January 27, 2003

**RESPONSES TO QUESTIONS FROM FCC ON THE SAR COMPLIANCE TESTING
OF ASKEY COMPUTER CORPORATION 802.11 a/b CARDBUS CARD (FCC ID#
H8NWLC221-D4) INSERTED INTO (IBM MODEL 2628*) LAPTOP COMPUTER**

This SAR test report was submitted on November 21, 2002. The two questions asked and our response is given in the following:

Fig. A. A photograph of the waveguide setup used for calibration of the Narda Model 8021 E-field probe in the frequency band 5.2-5.8 GHz.

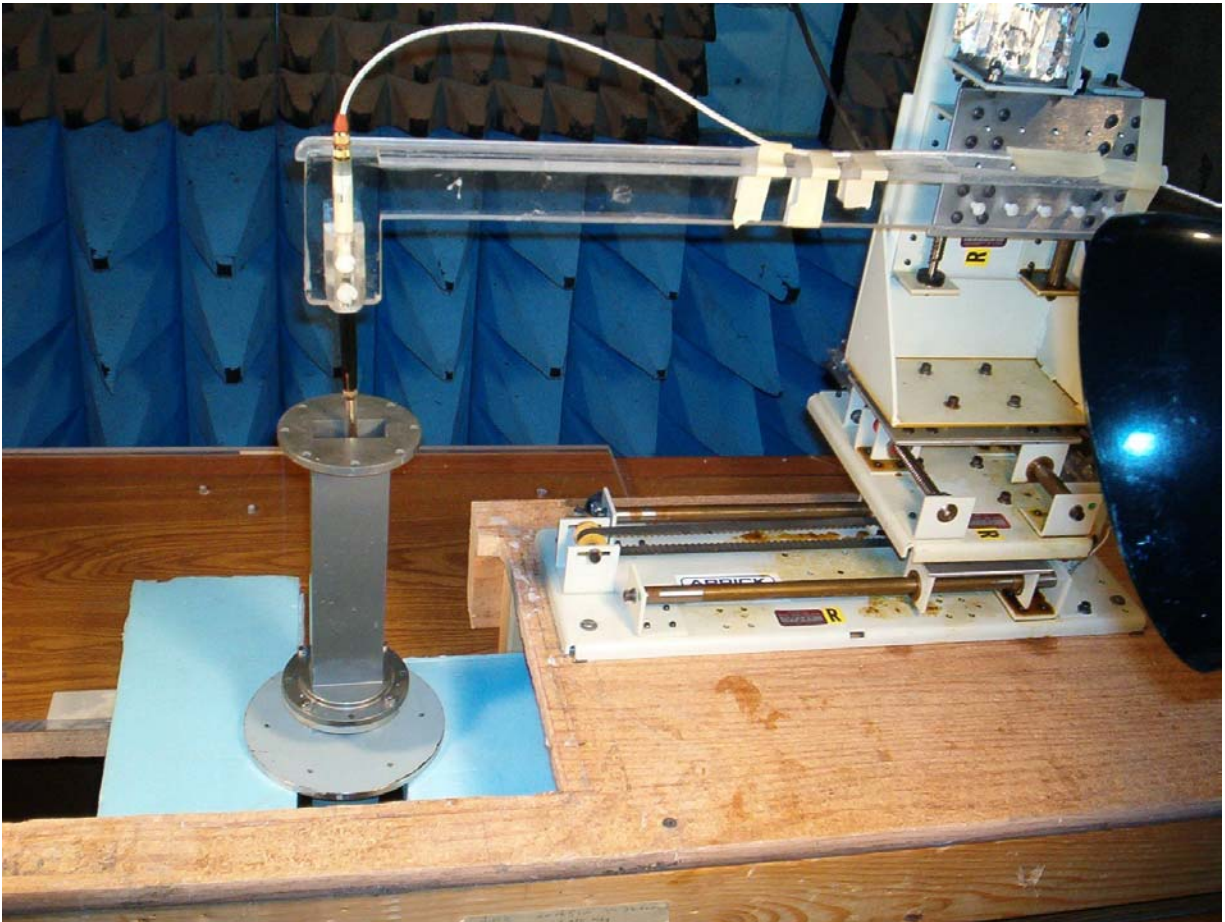
Q9. Additional calibration information for 5 GHz testing. Please include photographs of the key steps taken.

As suggested in the Draft standard P1528 [a], a waveguide (WR159) filled with the tissue-simulant fluid was maintained vertically. Two photographs of the rectangular waveguide filled to a depth of 15 cm with the tissue-simulant fluid are given as Figs. A and B. To prevent leaking of the fluid, the vertical waveguide section was sealed at the bottom by means of a 2 mm thick rectangular plastic plug. The Narda Model 8021 Miniature Broadband Electric Field Probe is inserted from the top and moved up or down vertically by the vertical stepper motor which is one of three motors for the SAR measurement setup (given as Fig. 3 of the SAR Test Report). As mentioned in Section II (The SAR Measurement System), the positioning repeatability of the stepper motor system moving the E-field probe has been measured to be within ± 0.1 mm [b]. From waveguide theory, one can write the expression for the decay of the fundamental TE_{10} mode fields in a rectangular waveguide filled with a lossy fluid [see e.g. ref. c]. By comparing the SAR (σE^2) associated with the square of the decaying electric fields for the TE_{10} mode with the measured output voltage (in μV) of the square-law detector of the E-field probe as a function of height above the bottom of the waveguide, we can obtain the calibration factor of the E-field probe for measurement frequencies of 5.2, 5.3, 5.7, and 5.8 GHz. The calibration factor thus obtained was 2.98 (mW/kg)/ μV with a variability of less than $\pm 2\%$ for these measurement frequencies.

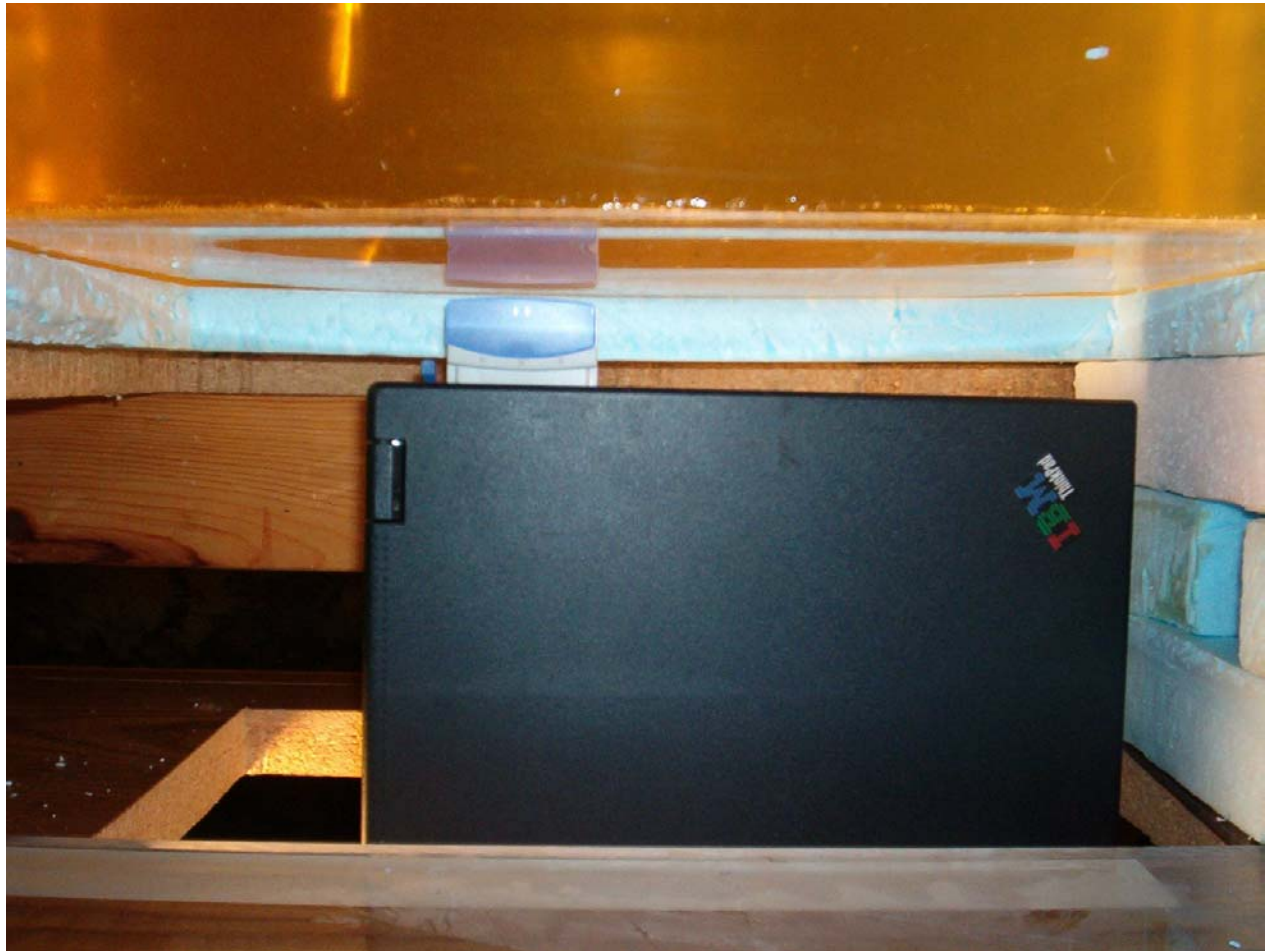
Q10. Additional photographs of the measurement setup for 5 GHz testing. Please provide improved quality photographs of the device against the phantom. Please provide additional perspective angles.

Similarly, a redone version of Fig. 6 of the SAR Test Report is included here as Fig. D. This photograph was taken for the Askey Corporation 802.11 a/b Cardbus Card inserted into the IBM Model 2628* portable computer placed with the card edge at 90° pressed against the bottom of the phantom i.e. with a separation of 0 cm for "end-on" testing of SAR. Note the reflection of the Cardbus Card in the tissue-simulant fluid.
